Date : January 19, 1962

Subject : Current Configurations of Pressure Suit and Parachute

FULL PRESSURE SUIT 1962
OXCART

IN RIG WITHOUT
NECK COLLAR SPREADER IN FIN'D 1ST STAGE
SUSPENSION POINT.

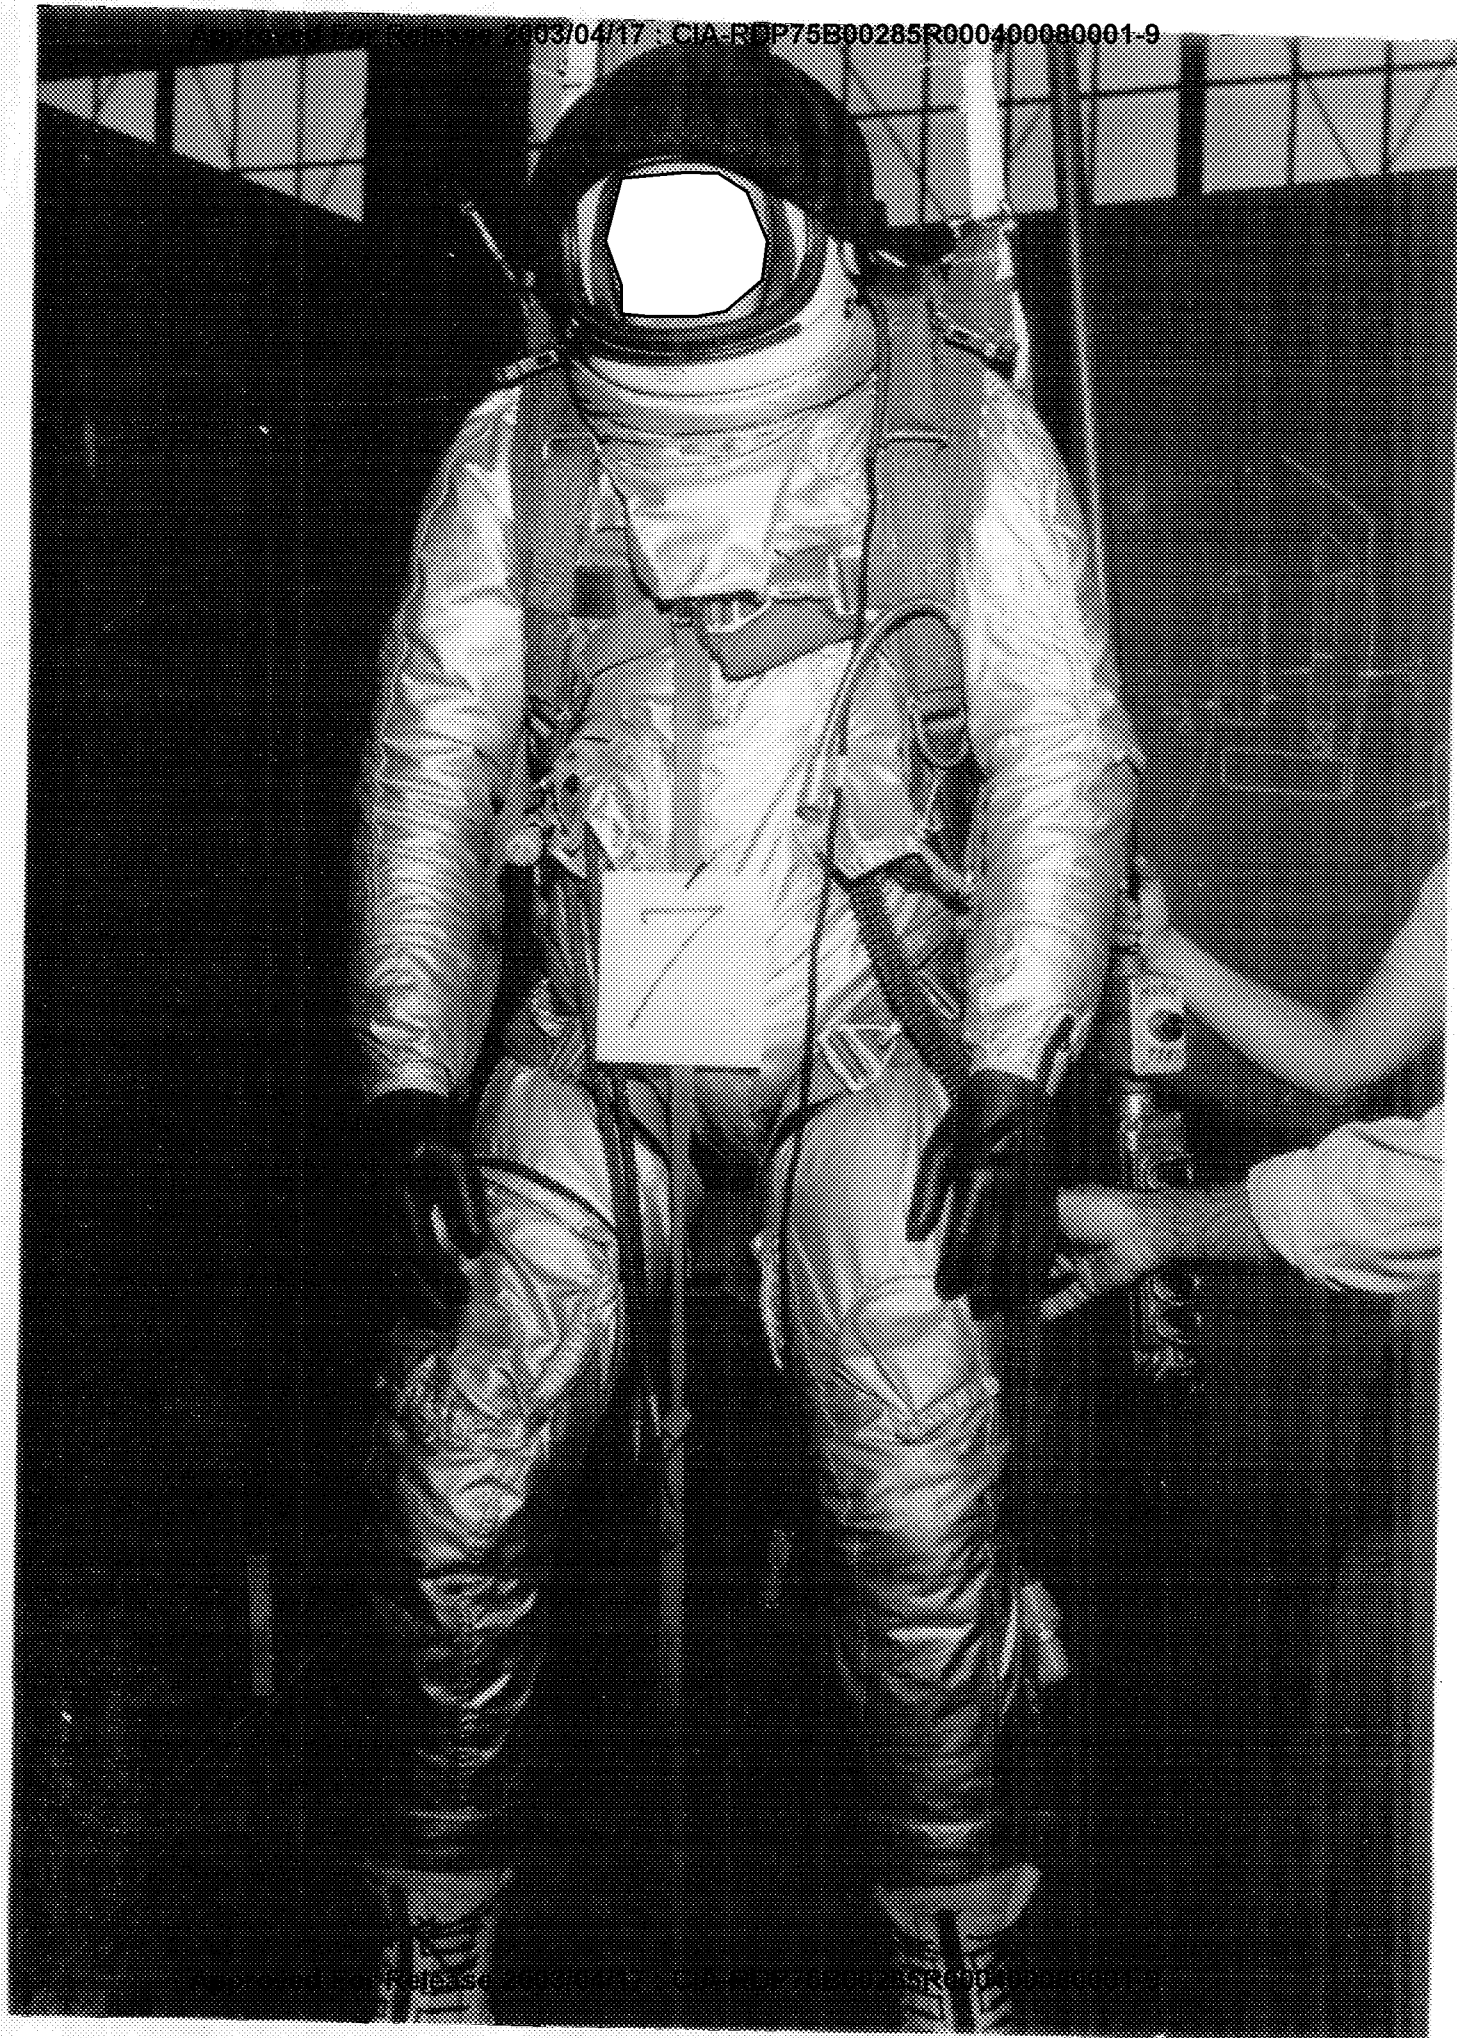
a) COMFORT BETTER THAN #5

b) SEEMS GOOD - NO CRITICISMS.

2. SUSPENSION 1ST STAGE IN AFT POSITION

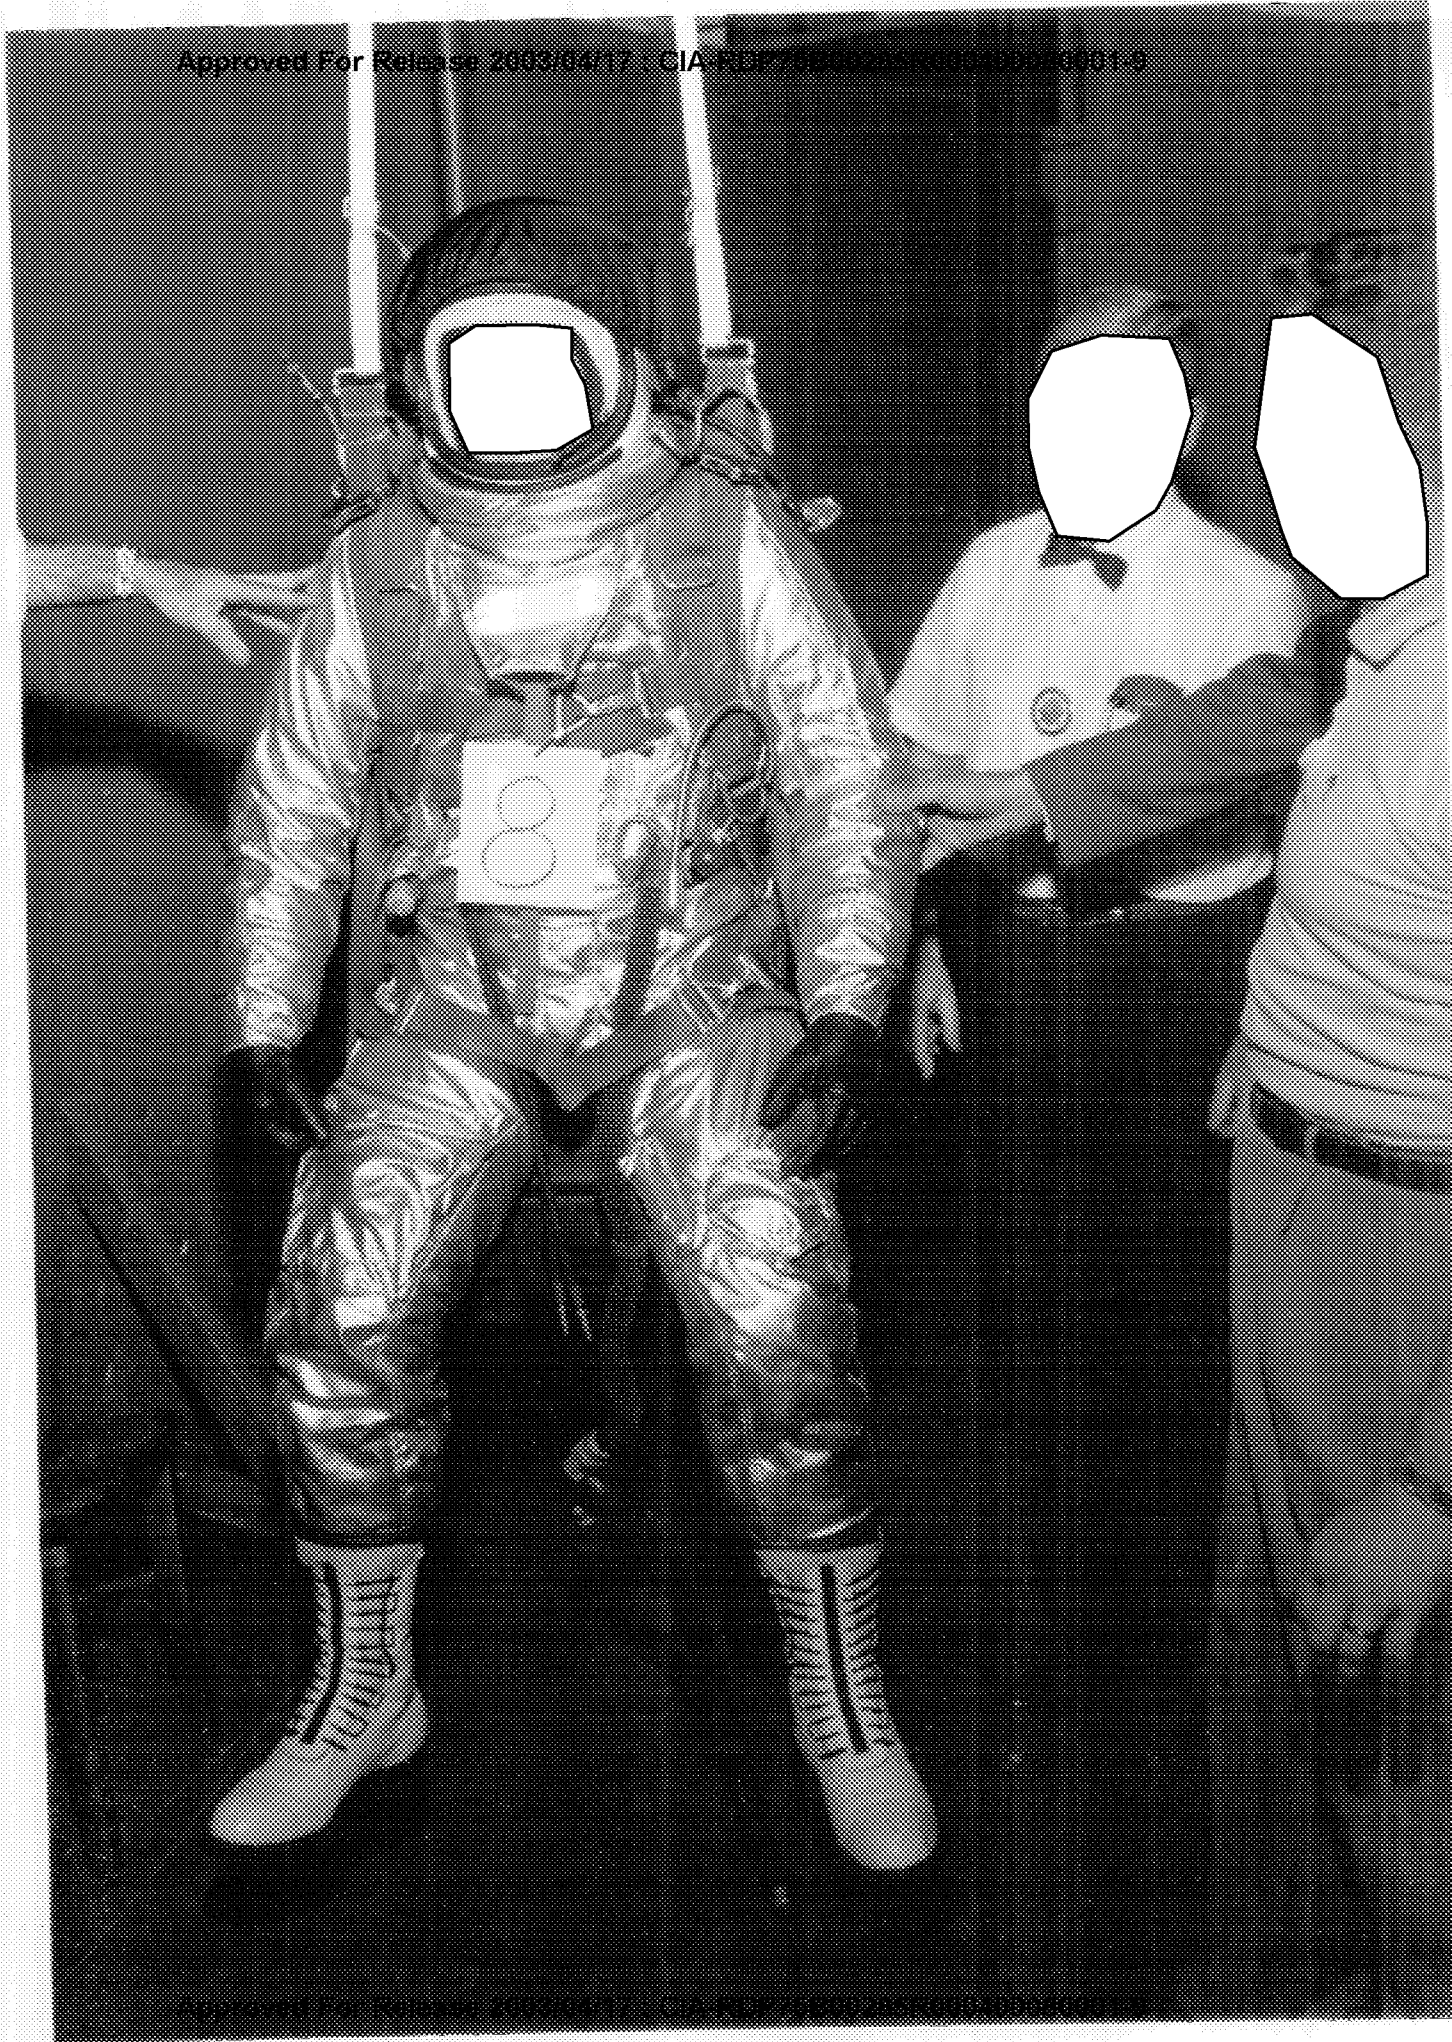
a) No OBJECTION ABLE CHEST PRESSURE

2) ... LEG

c) NECK

1. SAME RIG ~~DIFF~~ AS #8 WITH
1ST STAGE SUSPENSION FIW'D

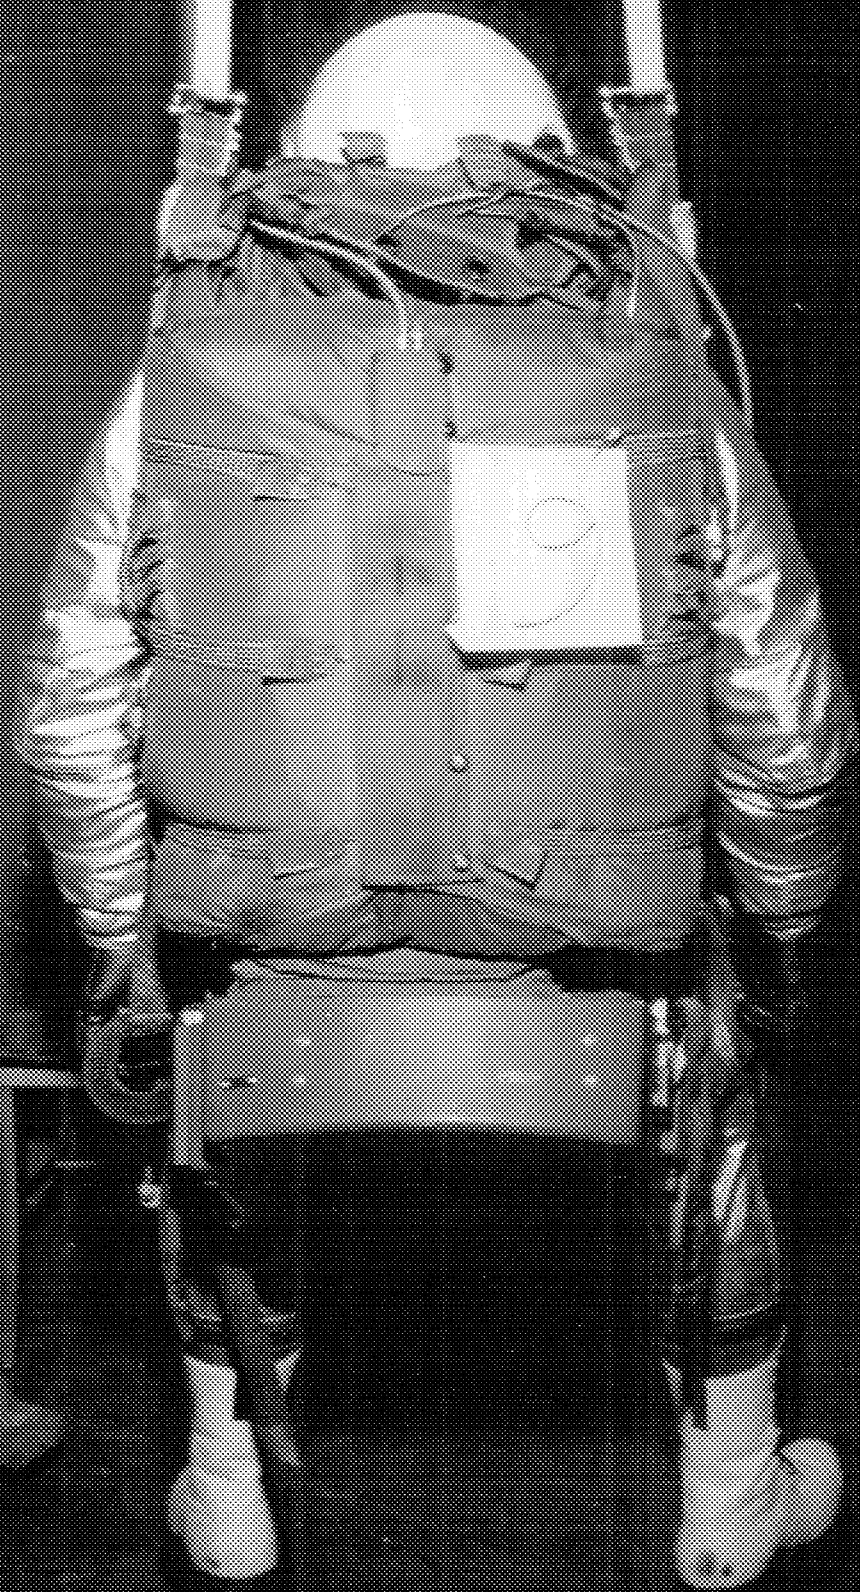
a) FEELS ABOUT SAME AS #8

Q) RIG WITH NECK SPREADER

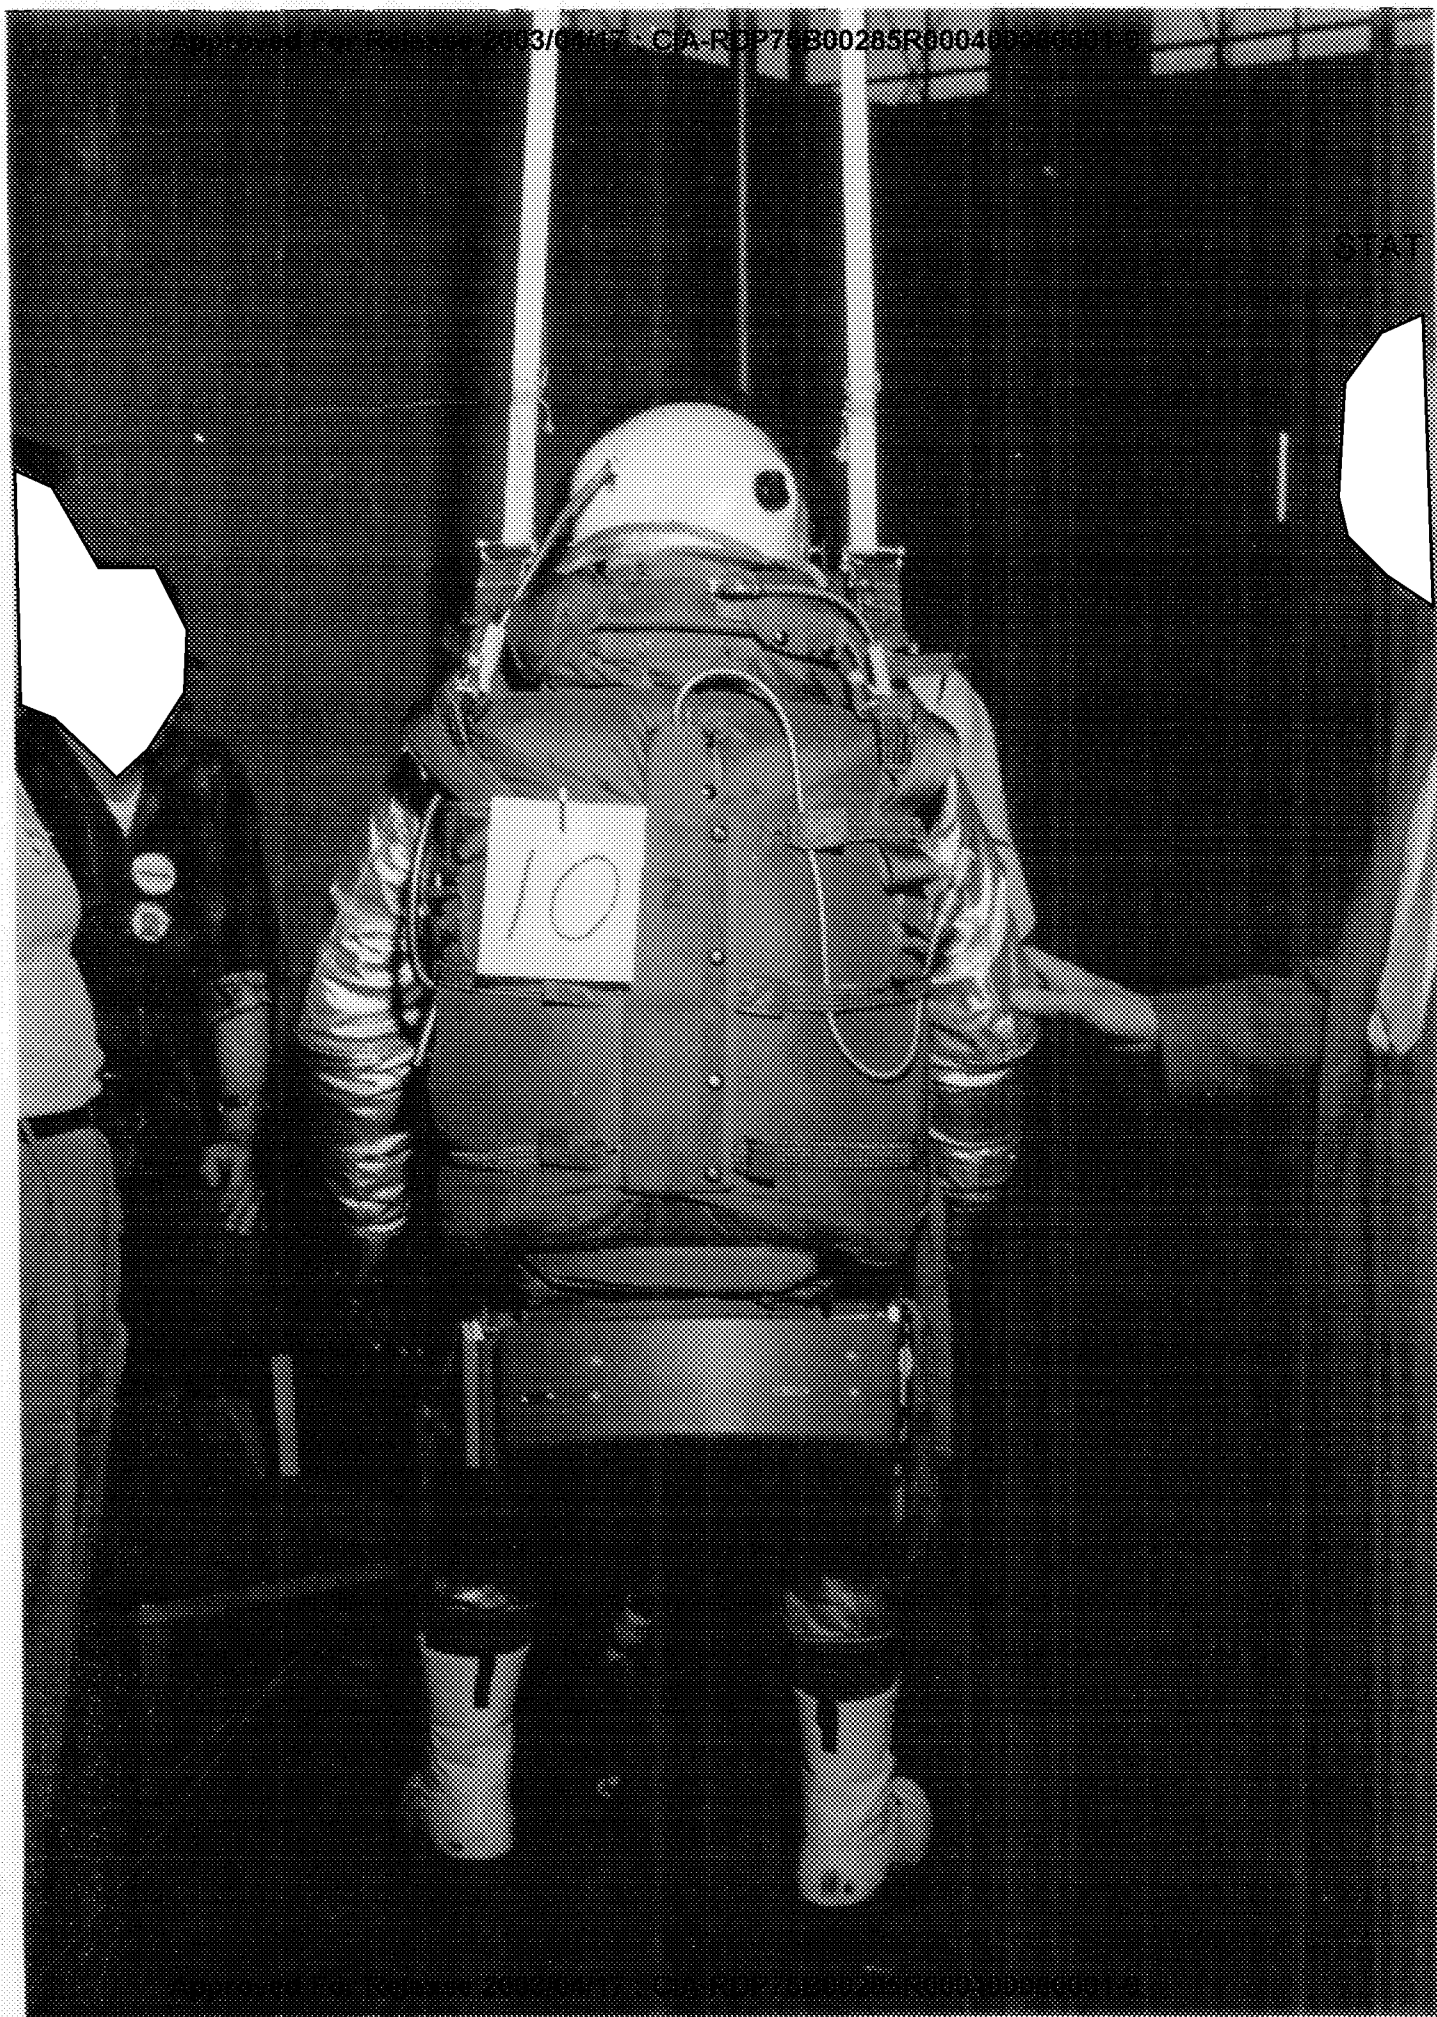
Q) SUFFERING

A) STRAIN ON NECK

DOESN'T WANT TO JUMP -
HURTS TOO MUCH
